FEEDBACK REPORT FORM

Ref No: 101-301107(S)

DRAWING NO. SE(EI)-20 REV. A.

TYPICAL INSTALLATION DETAIL OF ELECTRICAL POINT FOR COOKER HOOD, HOB & OVEN

Alpha Consulting Engineers Pte Ltd	Drawing No. SE(EI) – 20	Rev. B

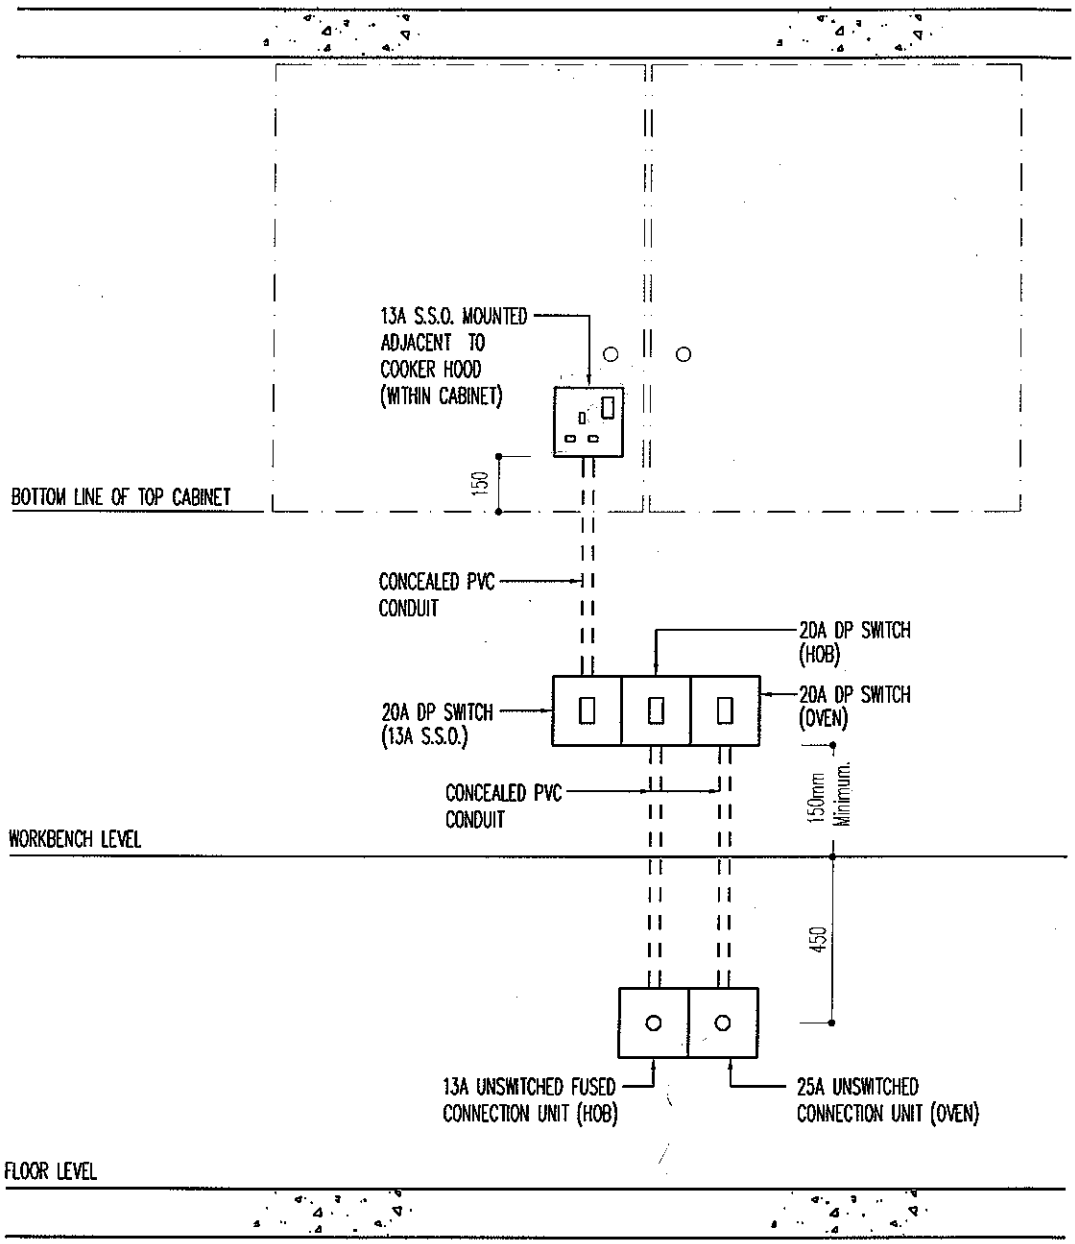
1) 13A S.S.O. WITHIN CABINET. NOT APPROVED BY SPPG AS IT IS NOT ACCESSIBLE.

2) 13A S.S.O 50mm ABOVE CABINET DO NOT COMPLY TO CP5

1) INTRODUCE 20A DP SWITCH FOR 13A S.S.O.

2) SHIFT 13A S.S.O. TO BE 150mm ABOVE WORKING SURFACE
